6. Preferred Infrastructure Report

This chapter documents and assesses 13 design changes that Transport for NSW proposes to make to the CBD and South East Light Rail (CSELR) proposal since the public exhibition of the Environmental Impact Statement (EIS). These design changes were identified as a result of ongoing design development, issues raised by stakeholders and the community during the EIS exhibition period, as well as further refinement of the constructability of the proposal. An assessment of the difference in environmental impact for each design change demonstrates that, collectively, they would represent a positive outcome for the proposal or can be adequately managed through the application of suitable environmental management measures (refer to Chapter 8 of this Submissions Report).

Figure 6.1 Proposed design changes

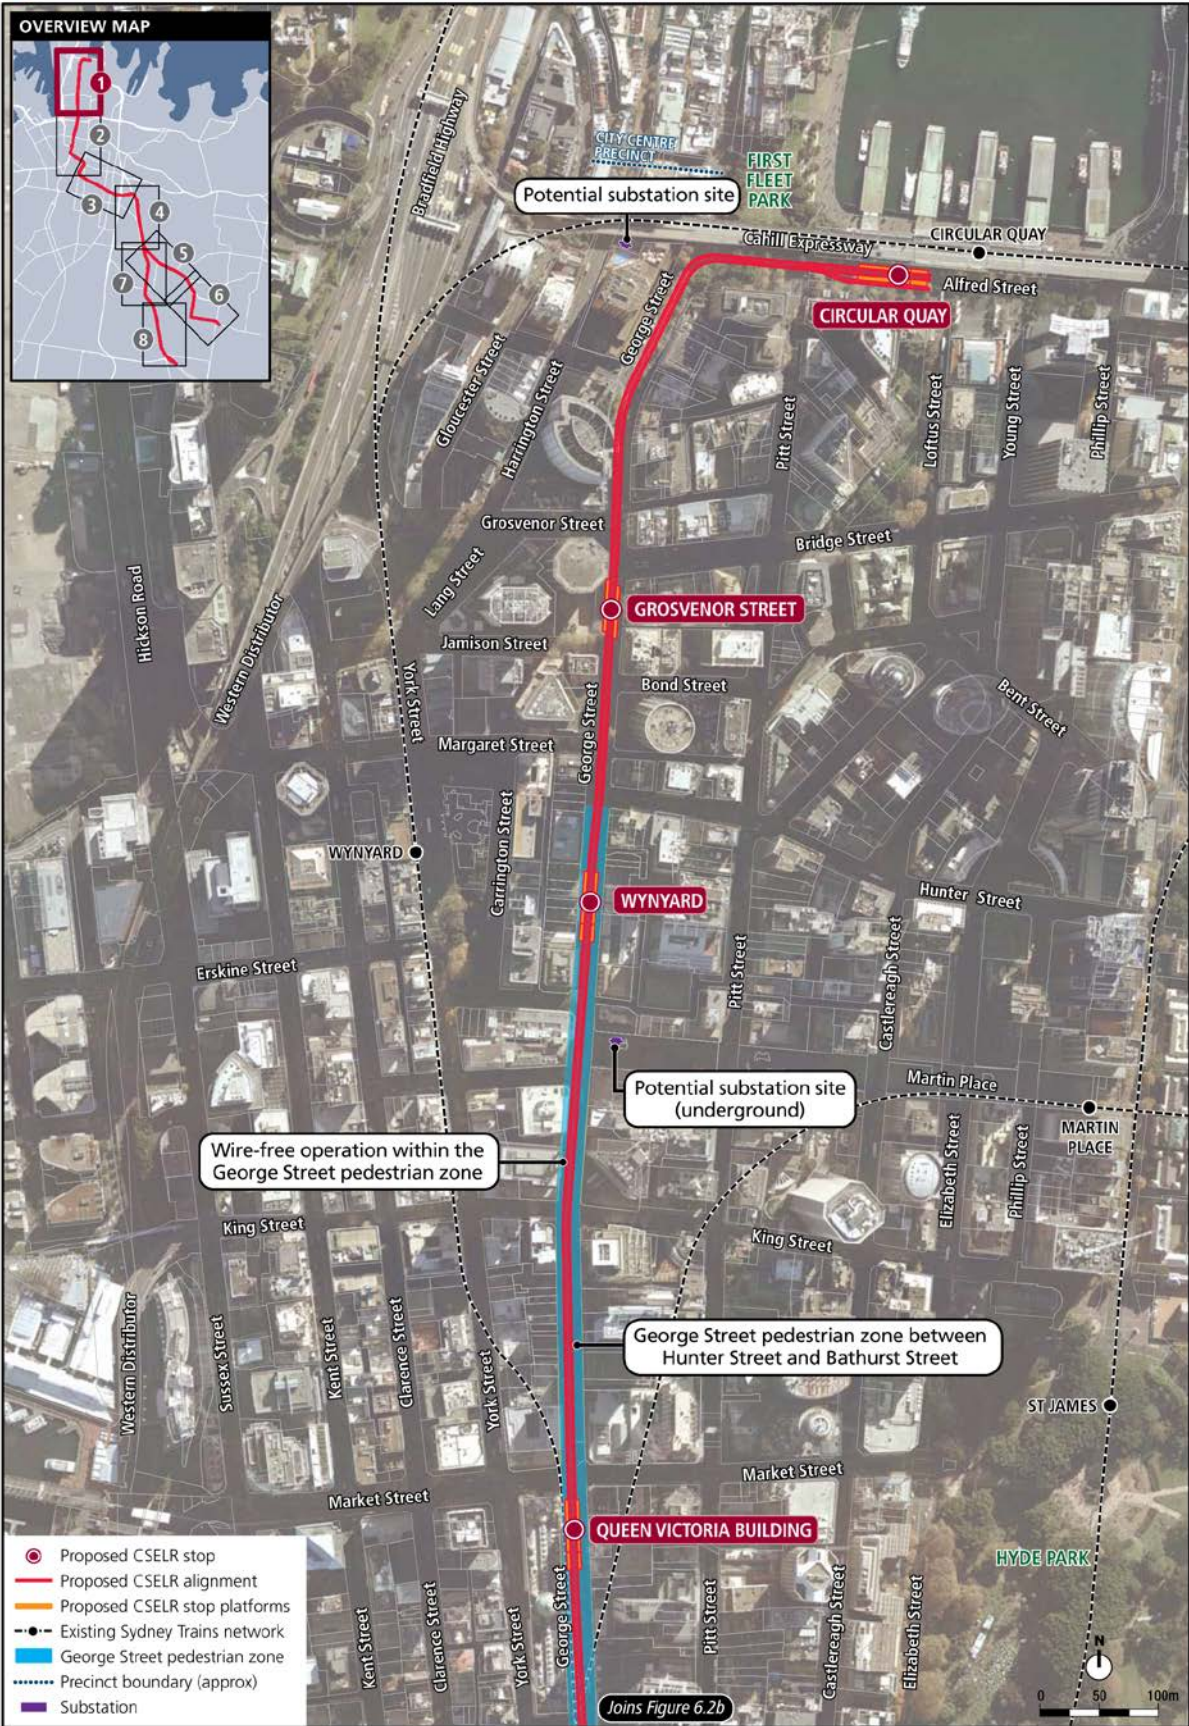
The locations of the above design changes are shown in Figure 6.1. An overview of the key features of the revised CSELR proposal is provided in Figure 6.2a to Figure 6.2h. These figures show the overall proposed design and key features of the CSELR including the design changes identified in this section of the Preferred Infrastructure Report.

Figure 6.3 Revised Central Station stop arrangement and revised functional use of the Chalmers Street sub-precinct

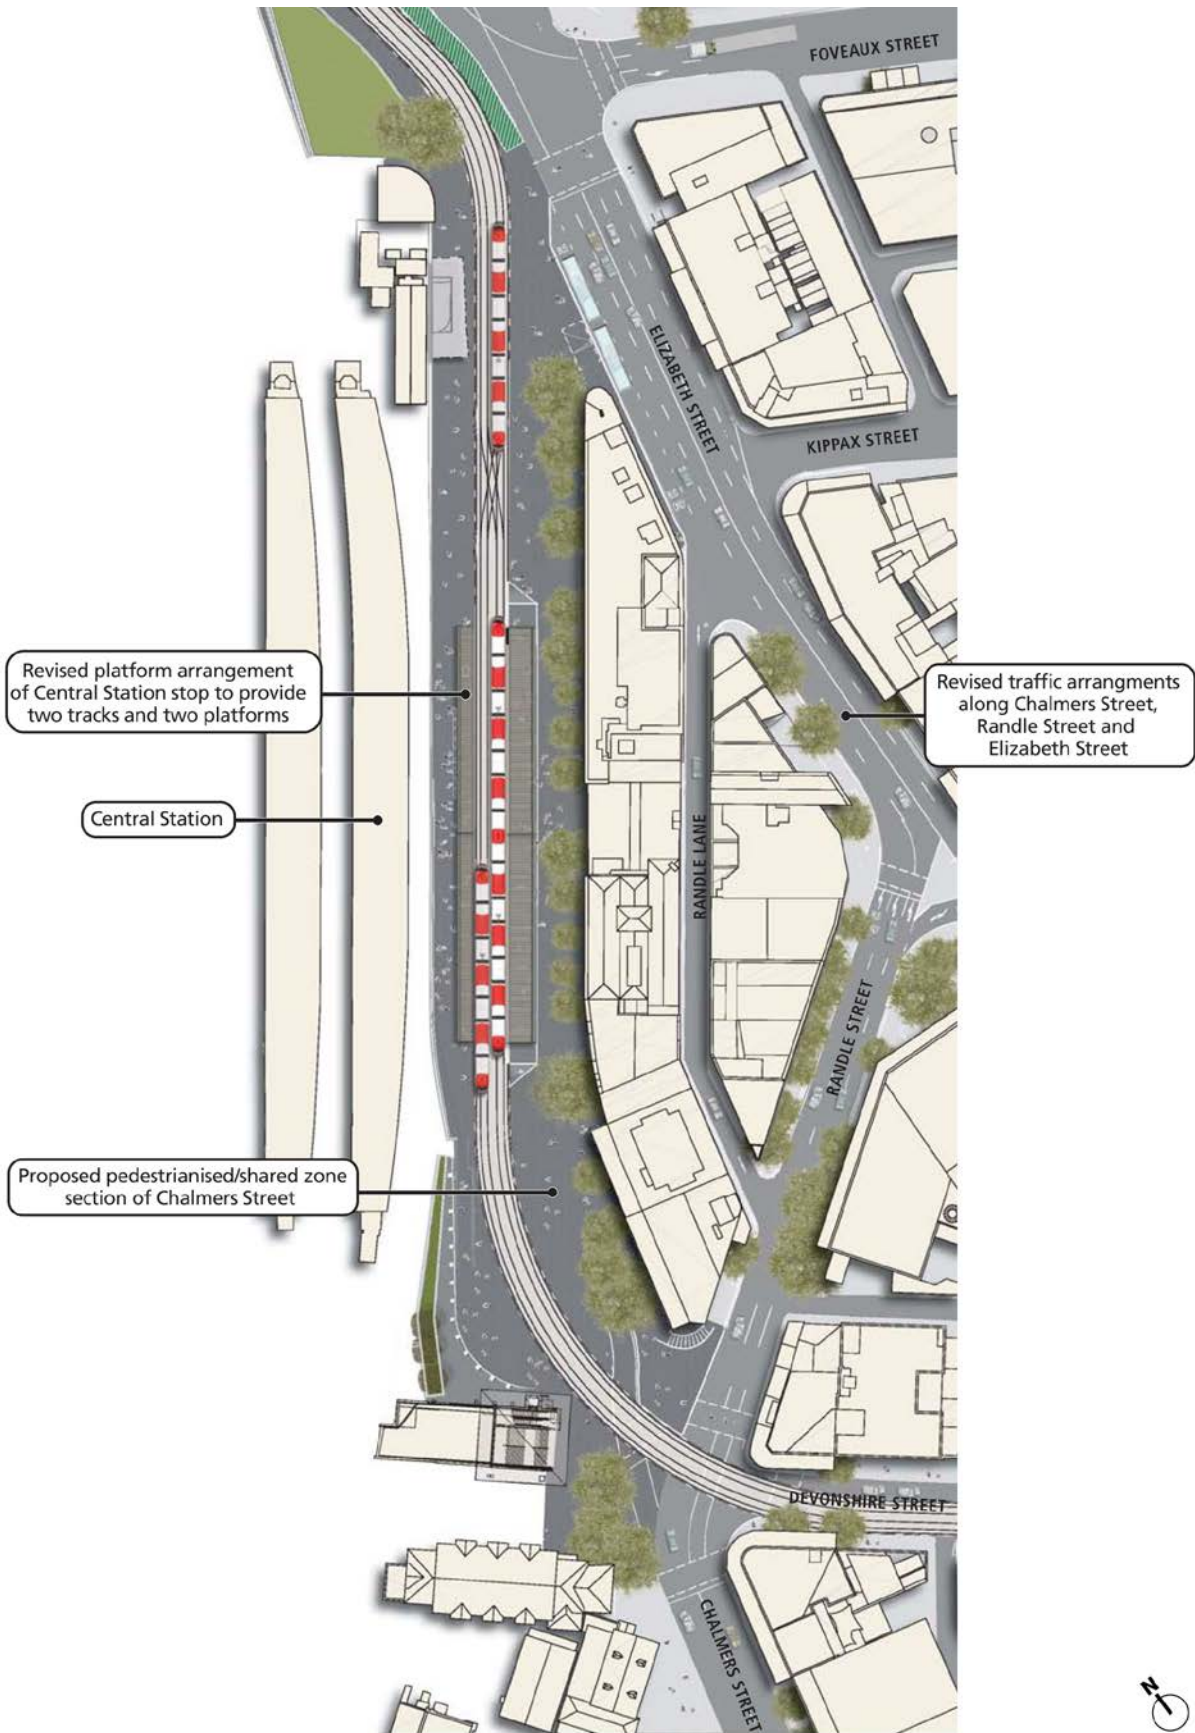
The revised design for the Central Station stop would remove the previously identified special event track and platform resulting in only two tracks and two platforms. In addition, the existing traffic lanes along Chalmers Street between Randle Street and Elizabeth Street would be removed and converted into a shared zone, allowing pedestrians, cyclists and vehicles access to properties in Chalmers Street in a low speed environment, resulting in no general traffic along this section of Chalmers Street, other than minimal access for local vehicles to existing accesses such as the Dental Hospital and residential properties.

The revised design for the surrounding street network would maintain Randle Street as northbound-only providing three lanes of traffic, including a single bus-only lane. Buses would not use the shared pedestrian and cycle zone along Chalmers Street. The revised design recognises the significant role of incoming buses delivering passengers to rail services at Central Station, and would maintain a northbound bus stop on Chalmers Street just south of Devonshire Street. The revised design would also provide a northbound bus stop on Elizabeth Street (south of Foveaux Street), adjacent to the existing southbound bus stop, providing easy access to Central Station via an existing lift on Chalmers Street.

Figure 6.6 Revised alignment and stop location within the Moore Park Precinct

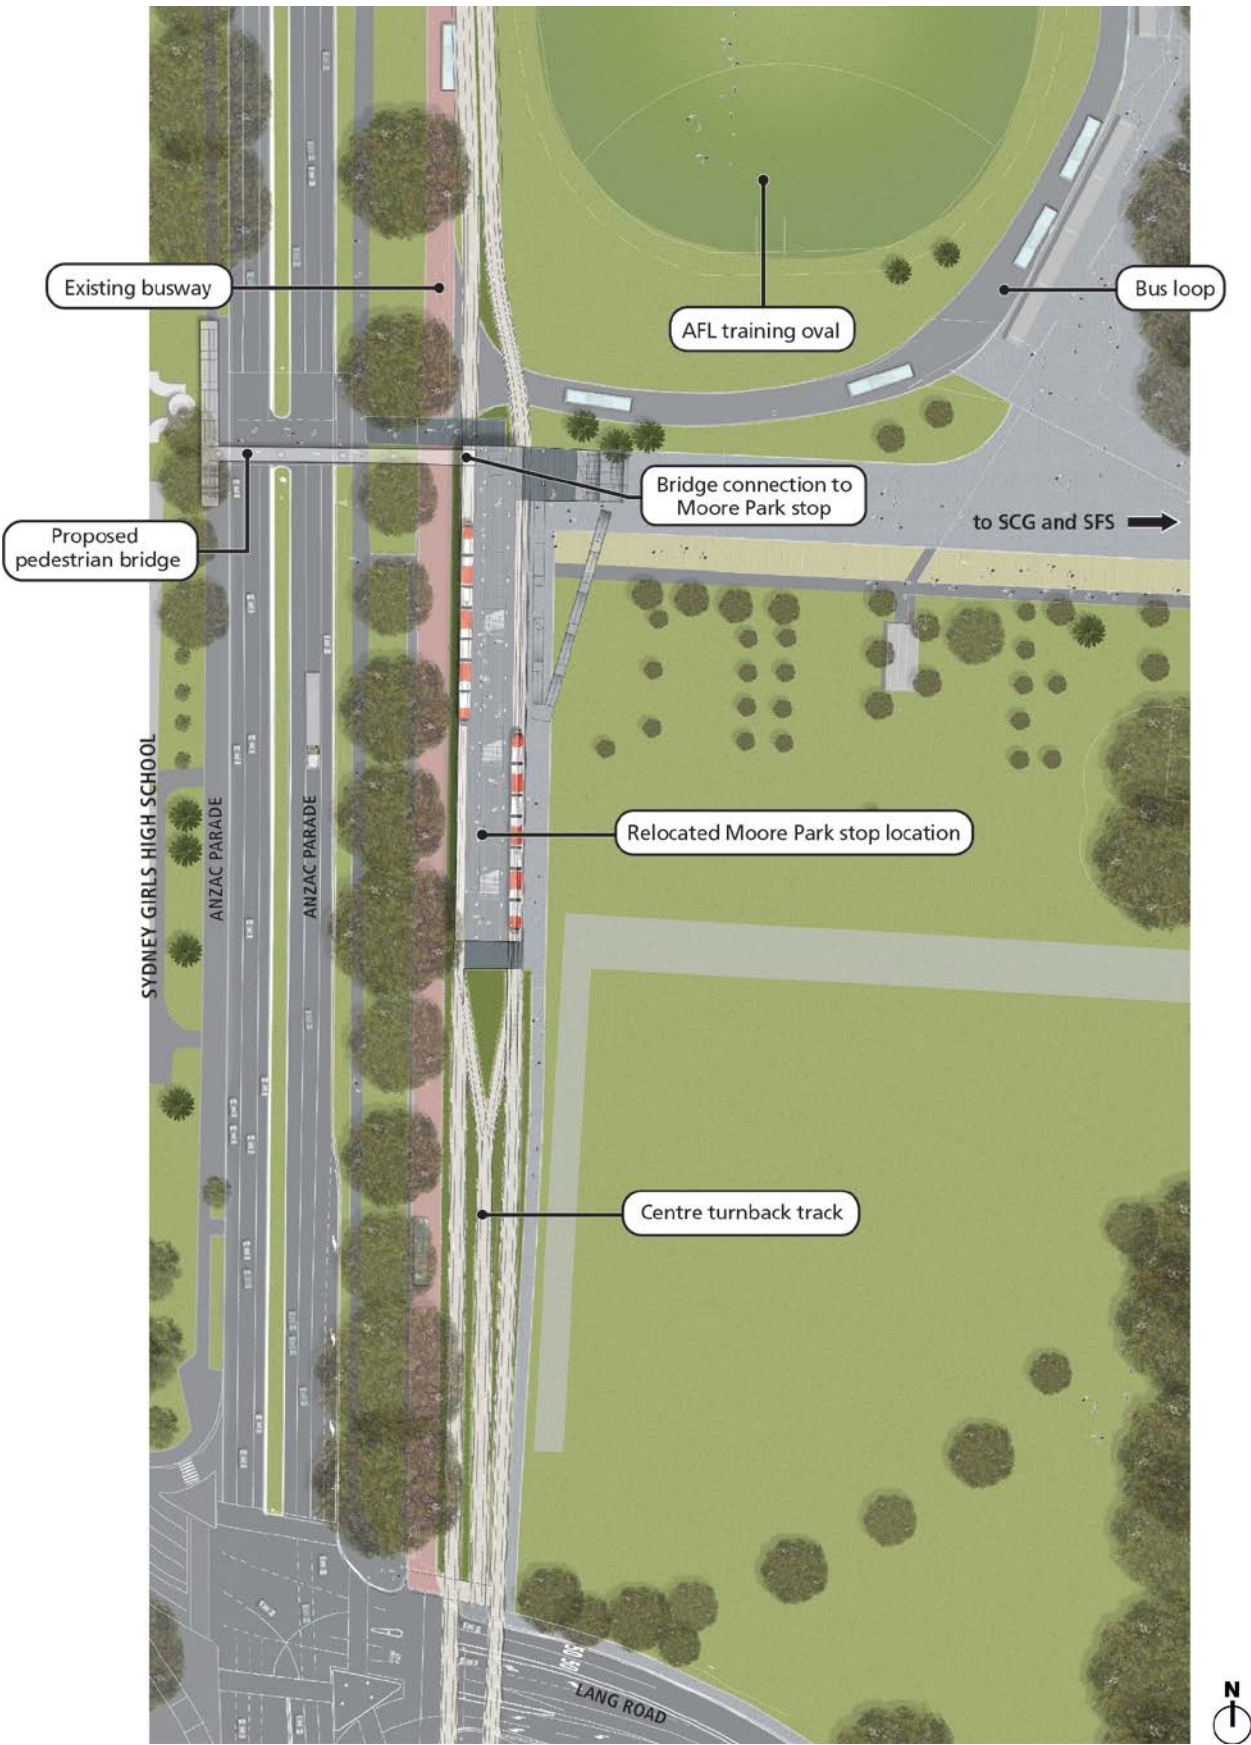
Following discussions with the Centennial Park and Moore Park Trust and ongoing design refinement, a revised location for Moore Park stop was identified to reduce the impacts on the existing AFL training oval during construction and operation of the CSELR. As a result of the relocation of the Moore Park stop, the alignment of the Moore Park tunnel has also been optimised.

The revised Moore Park stop would be located approximately 250 metres south of the previously identified stop location, to the south of the existing AFL training oval. The revised Moore Park stop would have a similar design to that described in the EIS and would continue to be configured to accommodate a 90-metre long island platform with a number of vertical access points to an above-ground mezzanine level for use during major events as a central marshalling area. A plan of the revised stop location is provided in Figure 6.6 and a plan of the proposed Moore Park stop layout is provided in Figure 6.7. The revised stop location would have a substantially reduced impact on the existing AFL training oval (which would be widened to the east by approximately five metres to allow for an increased player run-off area on the western side of the field) and would continue to provide access to the Sydney Cricket Ground and Sydney Football Stadium, whilst also providing improved access to other attractors in the local area including the Entertainment Quarter.

Figure 6.9 Elevation of the proposed pedestrian bridge over Anzac Parade (looking north)

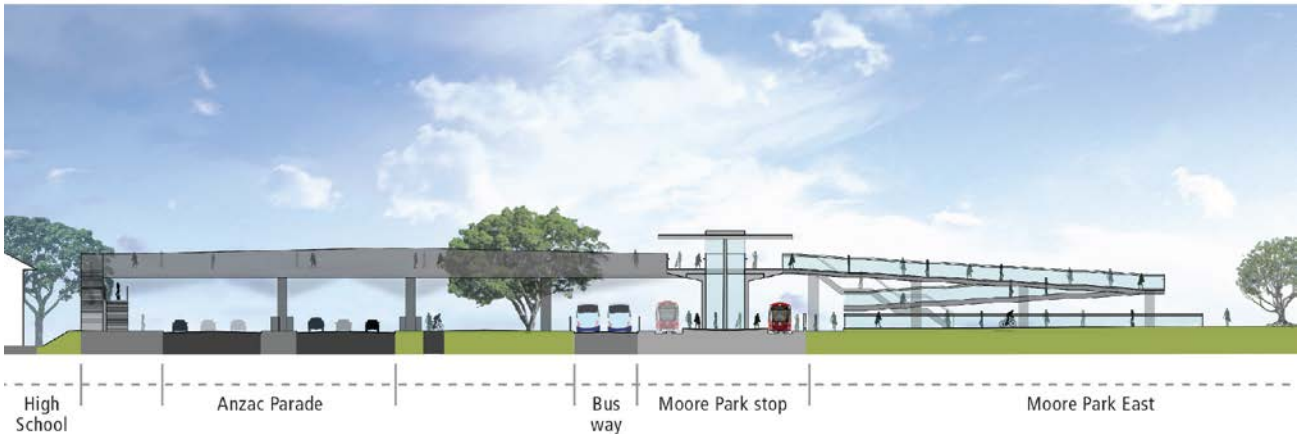
The Anzac Parade bridge would span approximately 55 metres over Anzac Parade, providing a grade-separated connection between the northern end of the Moore Park stop and the Sydney Boys and Sydney Girls High School campus (refer to Figure 6.7). The bridge would provide an approximately six metre-wide pedestrian walkway and a 5.5 metre height clearance to Anzac Parade. The final design of the bridge would be determined during detailed design.

Figure 6.15 Revised layout of High Cross Park

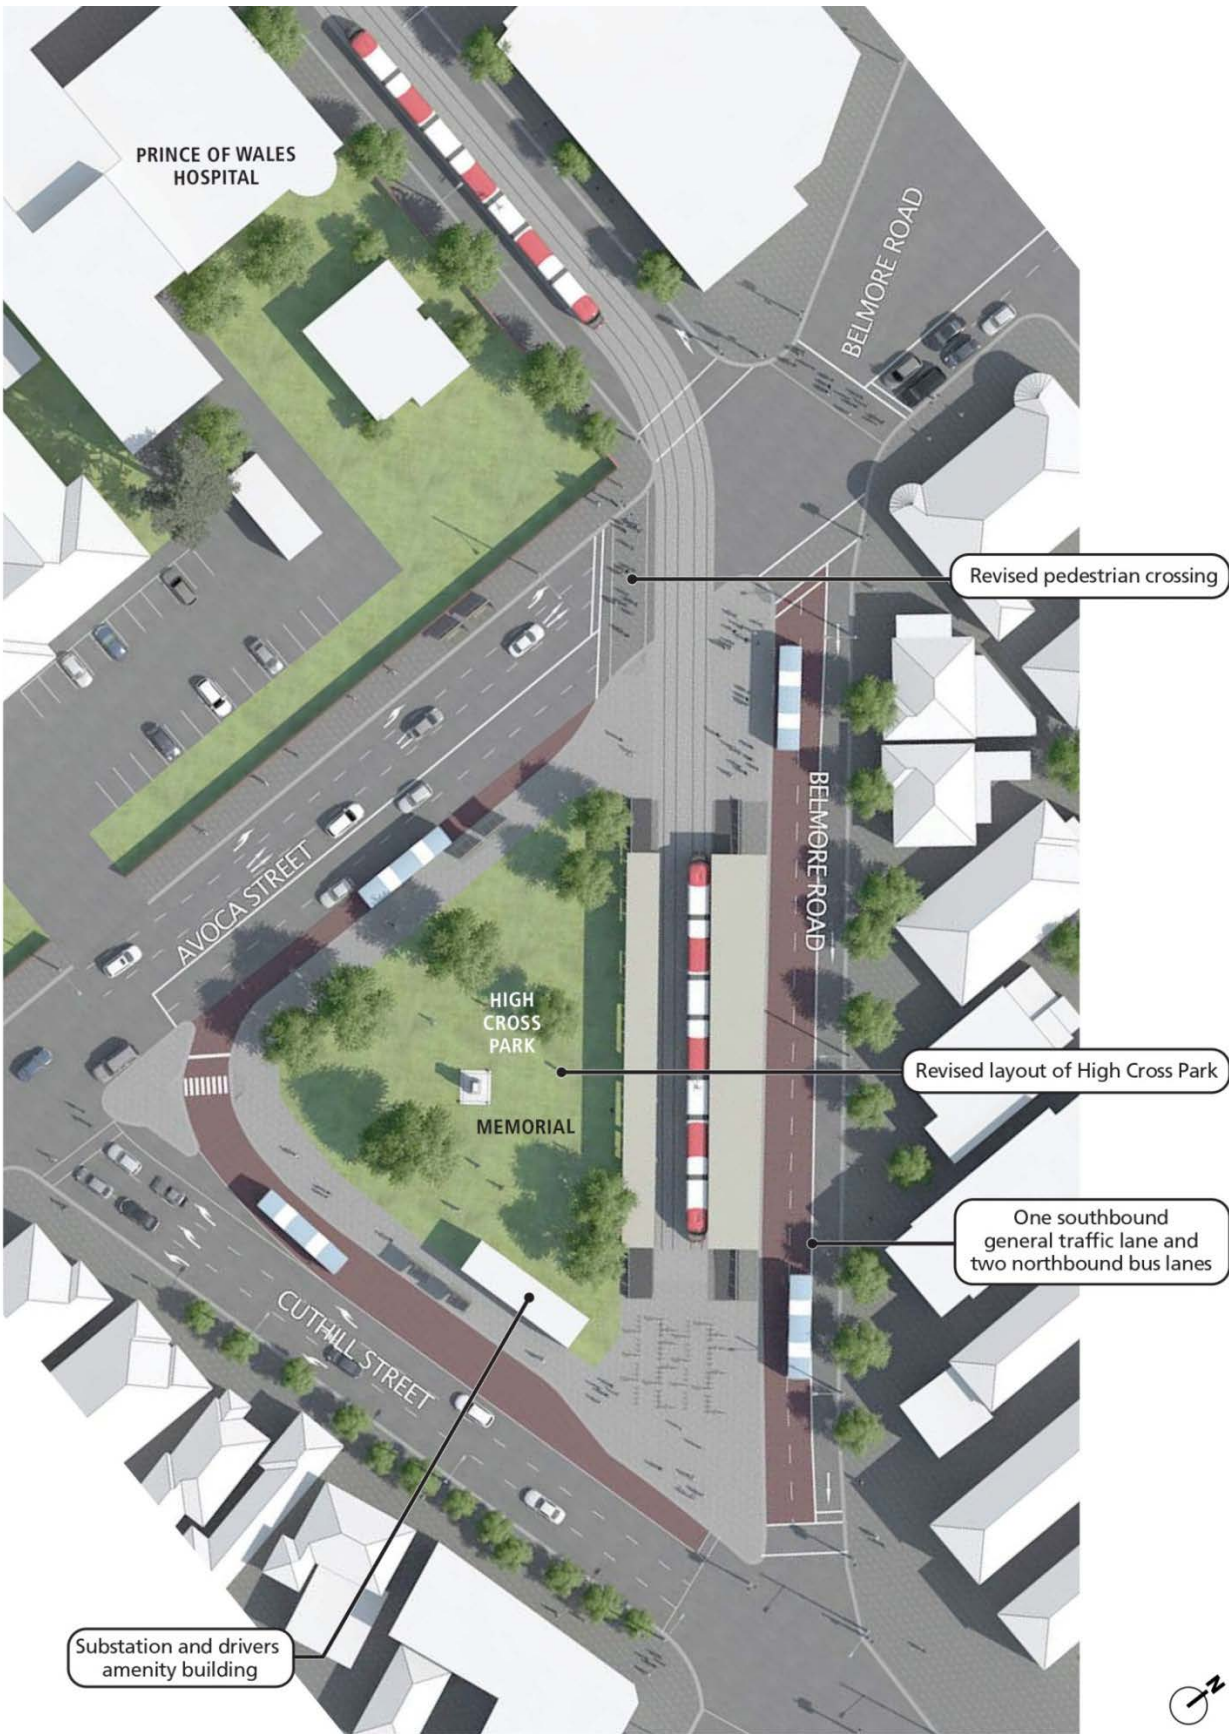
To reduce the overall impact of the CSELR within High Cross Park as a result of the submissions received, the light rail stop has been moved approximately three metres north towards Belmore Road (approximately one lane width) relative to the design presented in the EIS. The movement of the Randwick stop has been achieved by removing the existing southbound kerbside traffic and parking lane adjacent to High Cross Park. The removal of this lane allows the Randwick stop to provide an increased amount of parkland within High Cross Park, whilst also maintaining three lanes of traffic along Belmore Road including a single southbound lane for general traffic and two northbound bus only lanes (one for stopped buses to allow passengers to interchange to/from light rail and one permitting buses to pass). To accommodate this lane configuration, the existing northern parking lane would be replaced by the southbound traffic lane.

In addition to the movement of the stop, the revised design would also provide a larger turfed area within the park for local residents and workers than that proposed as part of the design presented in the EIS. It would also provide for an increased open setting of the existing RSL memorial in the centre of the park (relative to the EIS design), in order to retain the existing setting for the memorial.

Pathways within the park would be significantly narrowed and removed from the centre of the park, so as to maximise the amount of green space available. The pathways would also be repositioned to capture the primary pedestrian movements for interchange between the proposed bus stops and the light rail platform. The required bicycle storage facilities have been positioned to the end of the Randwick stop so as to minimise the impact on the open space of the park and provide a suitable interchange with the light rail.

The substation and driver amenities building would also be slightly reconfigured within the south-eastern corner of the park, which is considered the optimal location for this facility to maximise the functionality and minimise intrusion into the park.
